**Re: Responses to Information Requests  
Environmental Assessments - Prairie Creek Mine**

- **Phase II Mineral Exploration Drilling Program**  
(Land Use Application MV 2001C0022; MVEIRB File EA01-003)
- **Metallurgical Pilot Plant Program**  
(Water Licence Application MV2001L2-0003; MVEIRB File EA01-002)
- **Underground Decline and Exploration Drilling**  
(Land Use Application MV2001C0023; MVEIRB File EA01-002)

**Canadian Zinc Corporation Pilot Plant Environmental Assessment  
Response to Information Request**

PROJECT	PRAIRIE CREEK MINE
TITLE	TAILINGS DAM REHABILITATION
PROJECT No.	0059-002-04
DWG. No.	06
REV	C

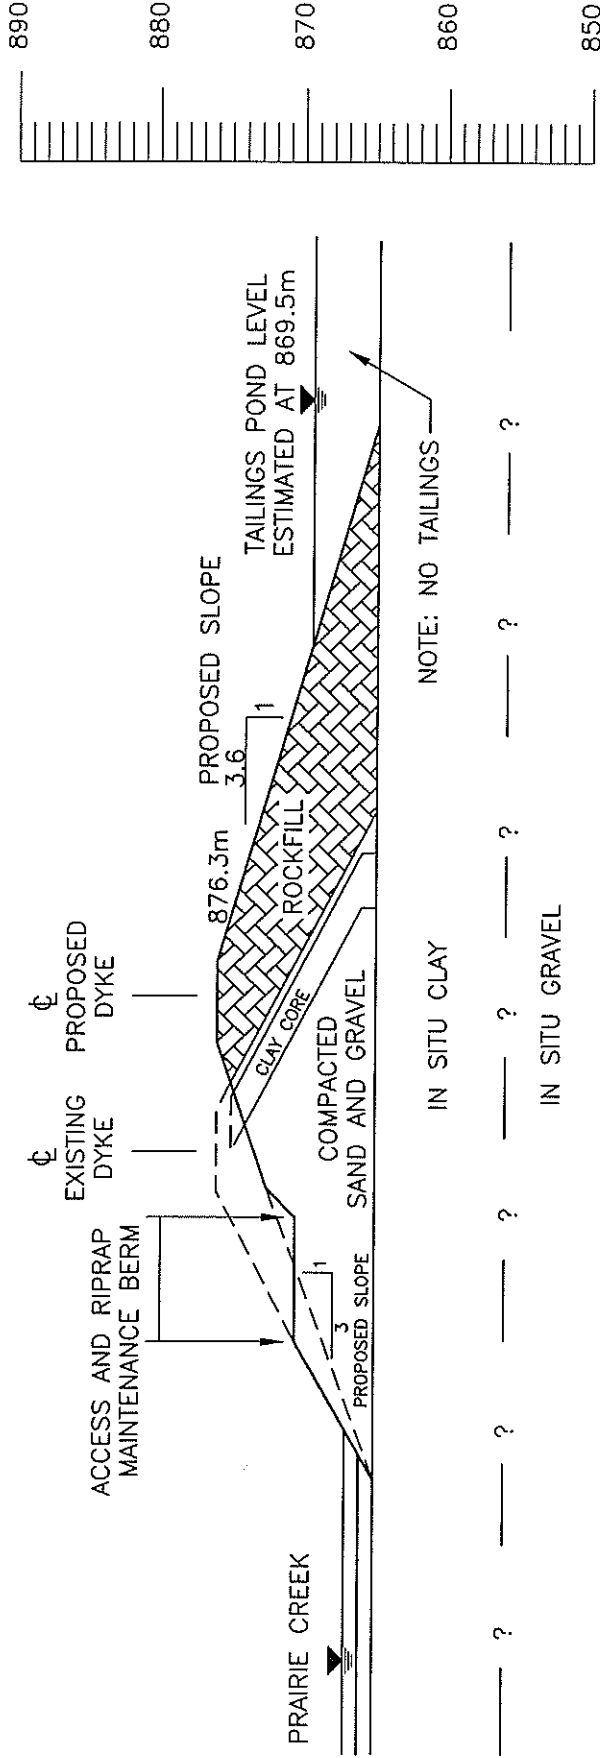
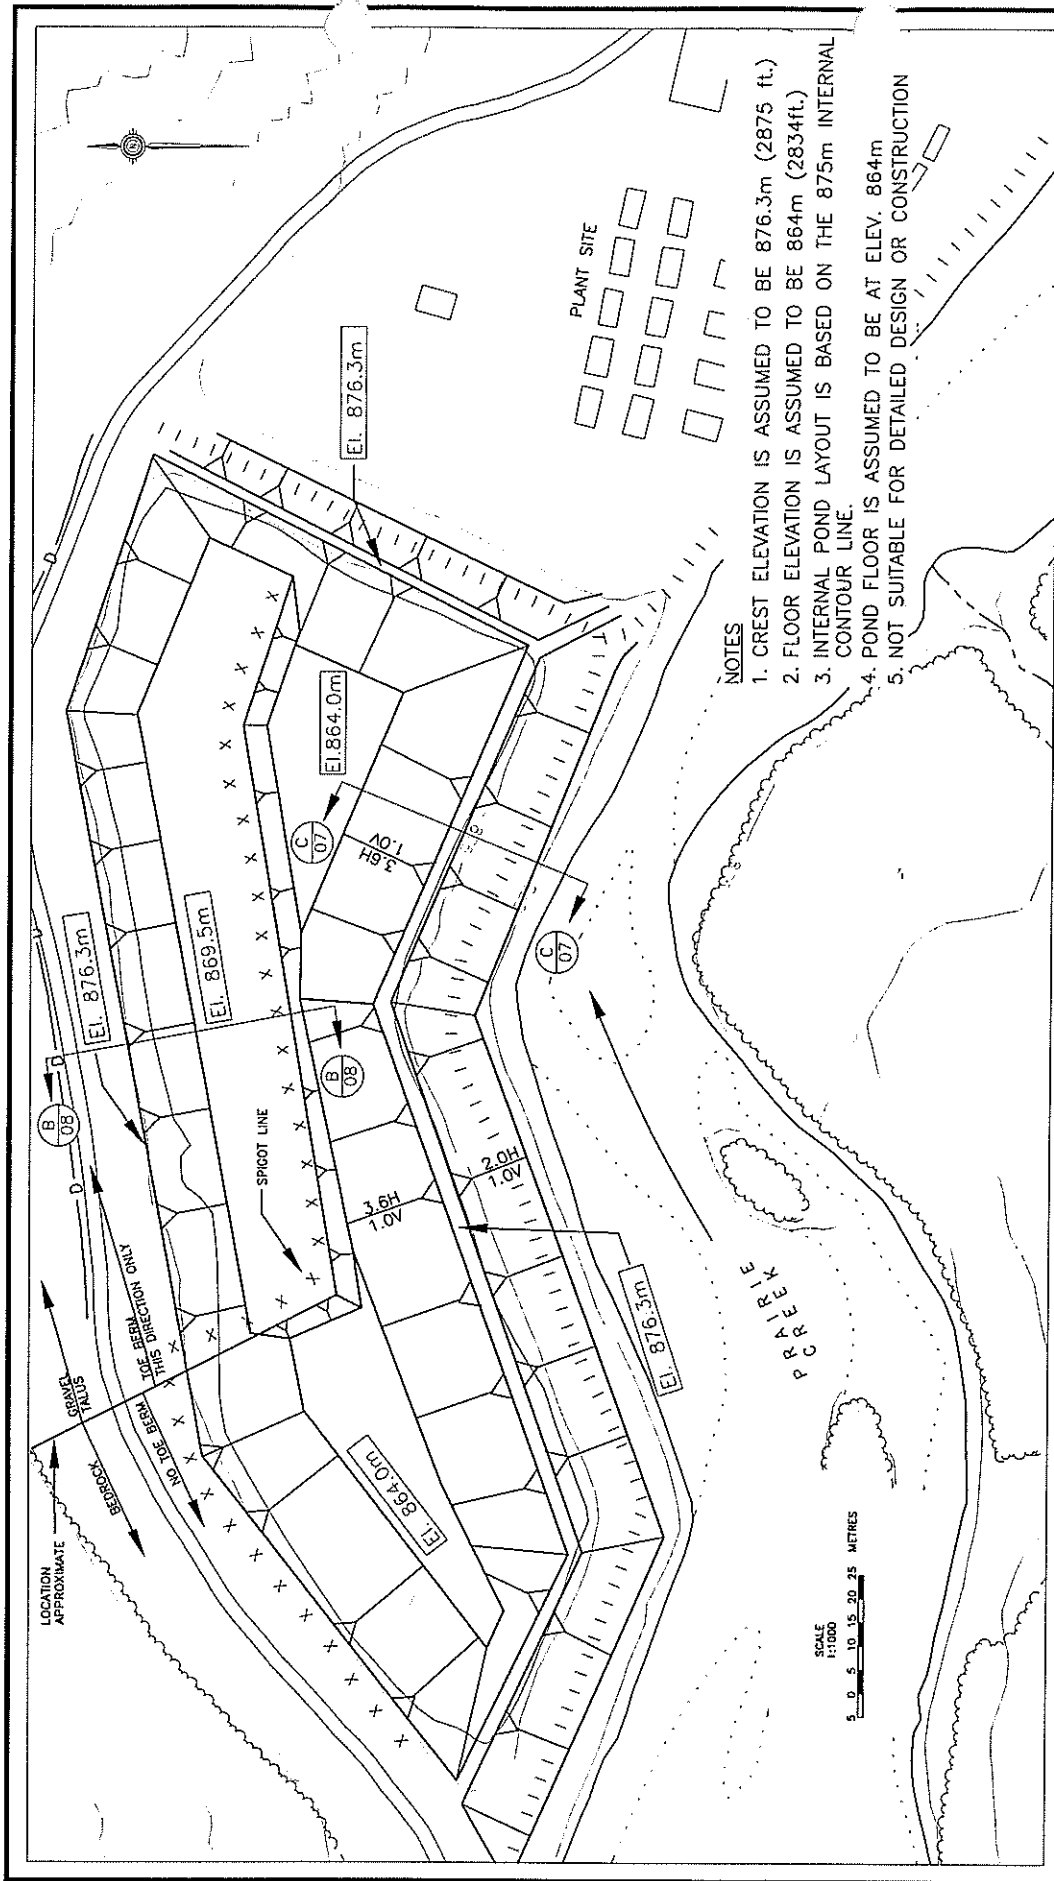
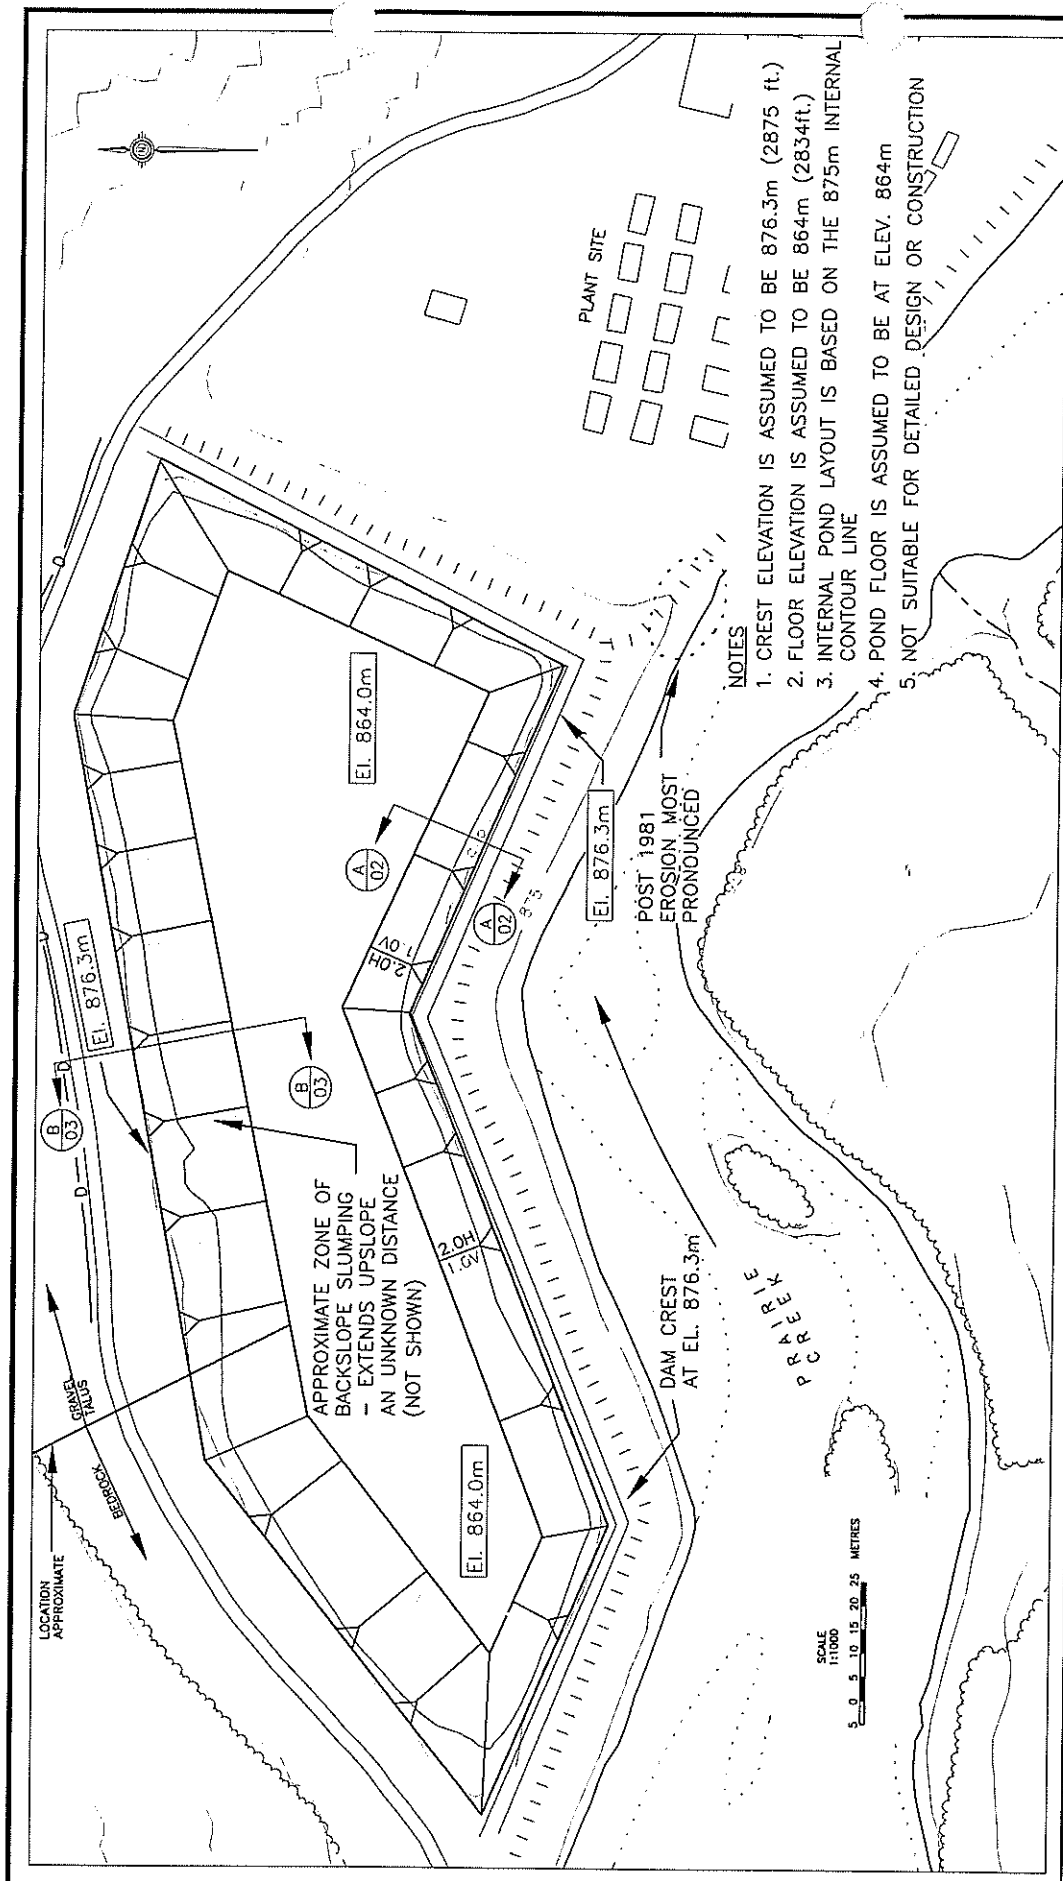
For the purpose of estimating a "worst-case" construction cost, a conceptual re-designed configuration of the embankment structure is shown in Drawings 06 and 07, plan and cross-section views, respectively.

unreasonably<sup>2</sup> low factor of safety shown in Drawing 04, indicating the upstream and downstream slopes must be re-configured to achieve an acceptable factor of safety. The slopes shown in Drawing 07 provide the following minimum factors of safety based on a preliminary analysis:

- Downstream slope - factor of safety about 1.2 for a slope of 3H:1V (see Drawing 07).
- Upstream slope - factor of safety about 1.1 for a slope of 3.6H:1V (See Drawing 07).

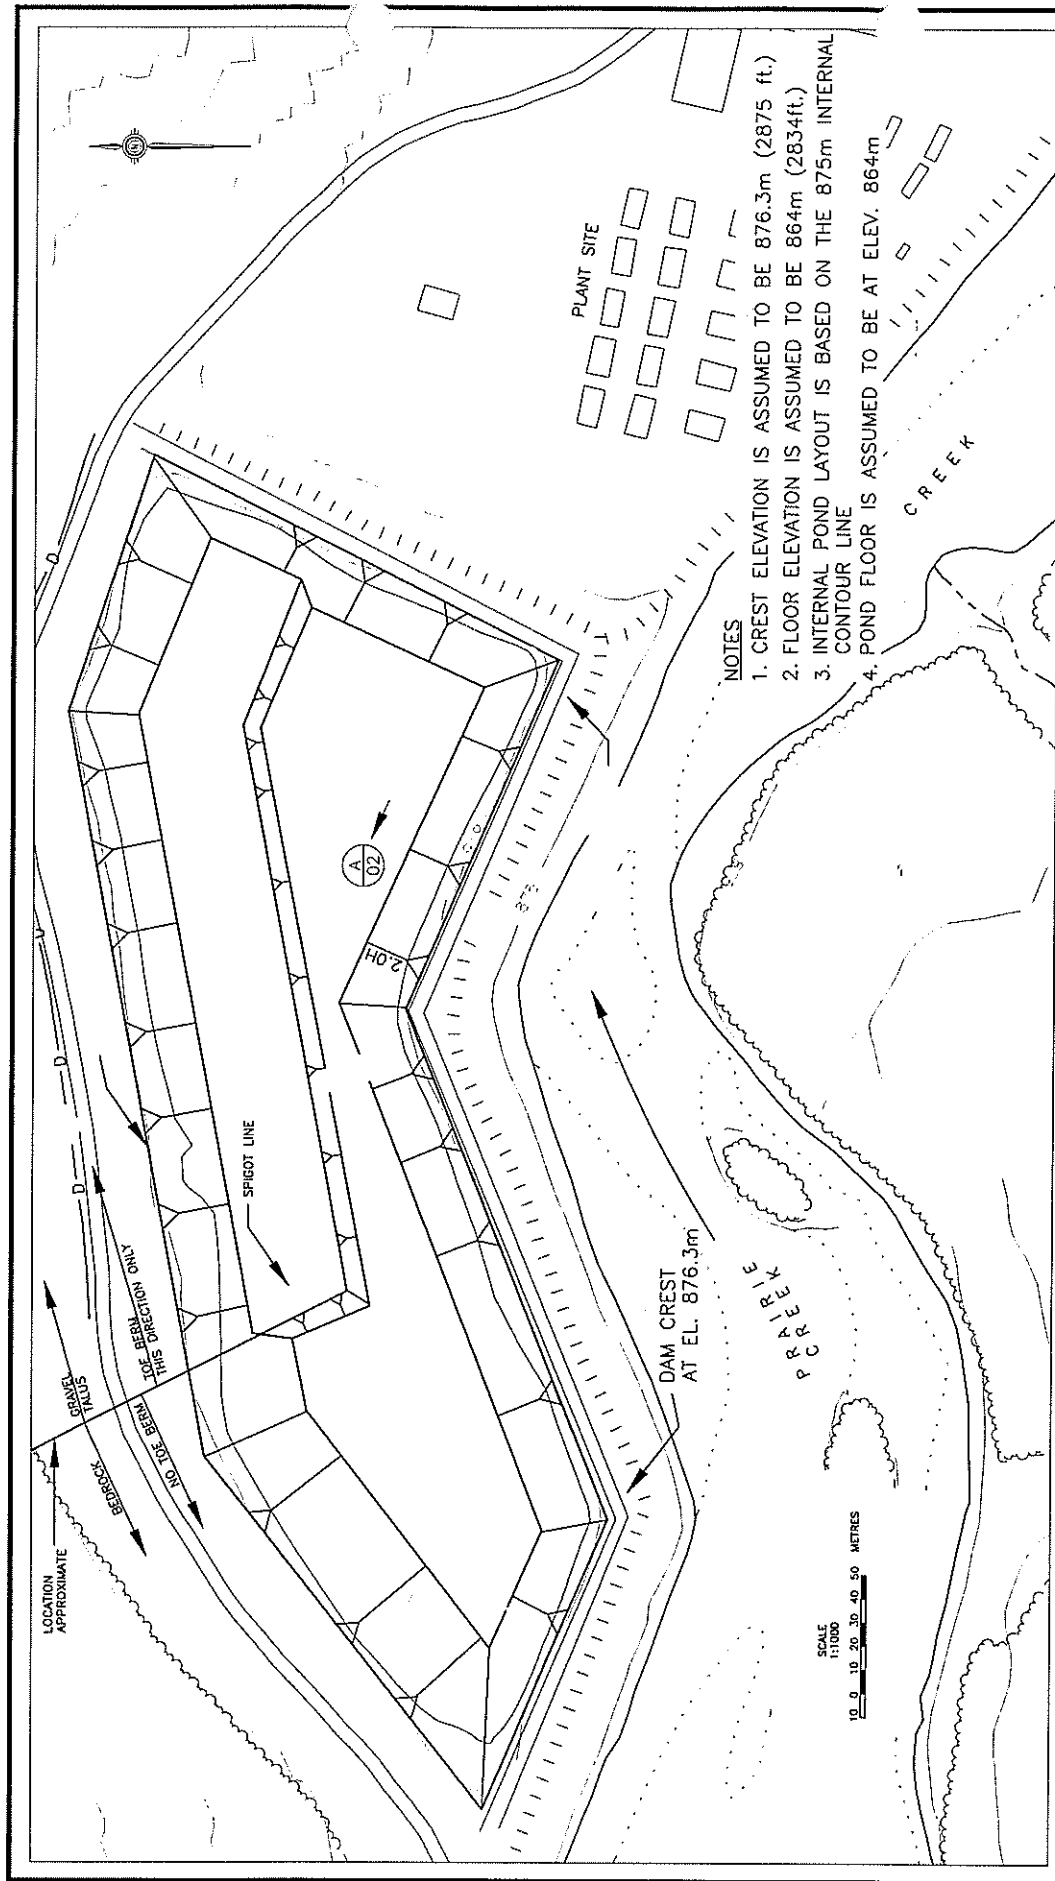
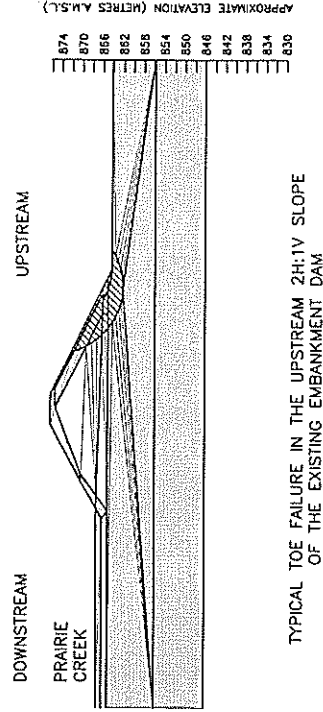
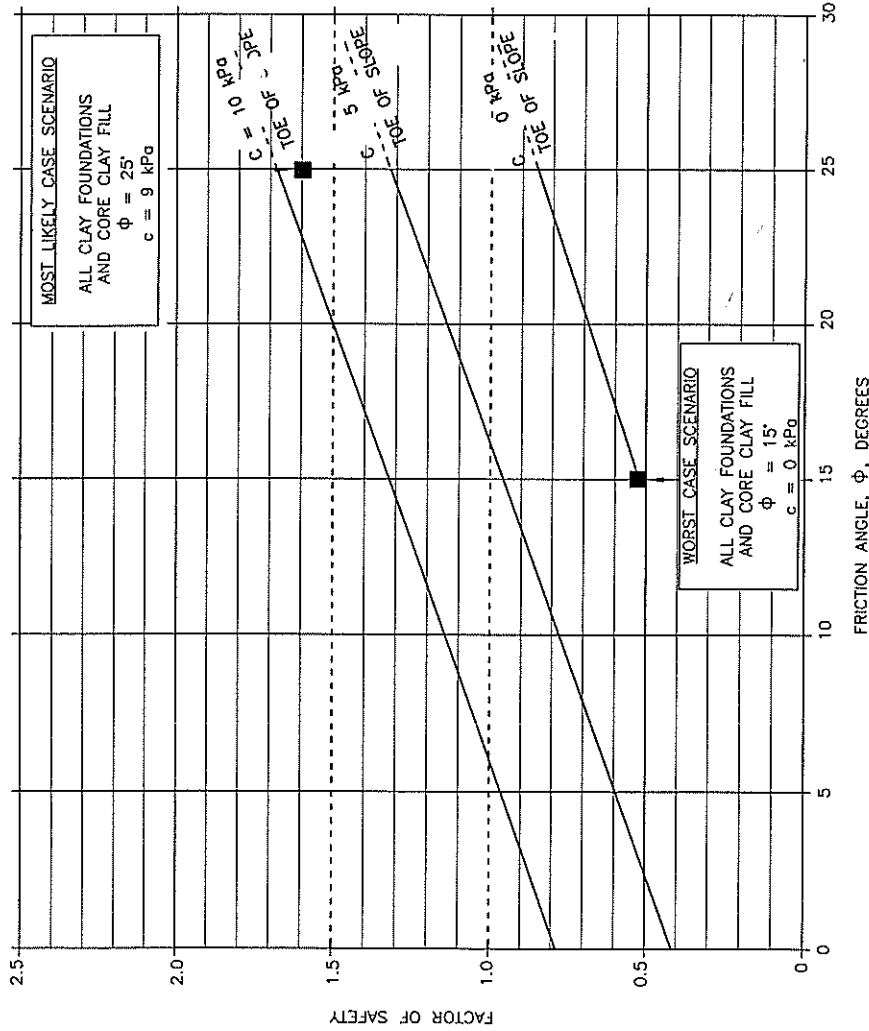
The "most likely" scenario for remediation of the embankment structure is to simply adopt its current configuration as shown in Drawings 05 and 02, plan and cross-section views, respectively.

The results of preliminary stability analyses support this configuration as shown in Drawing 04. This is reinforced by the fact that the embankment has remained essentially unchanged since the early post-construction period when the sand and gravel cover sloughed off and into the pond. Drawing 04 shows the factor of safety is calculated to be about 1.6, based on our best estimate of in situ soil properties, which are also listed on Drawing 04. Similar factors of safety can be expected for the downstream slope. As both embankment slopes are unchanged under the "most likely" scenario, there is no loss to the tailings pond volume due to the embankment dam rehabilitation.
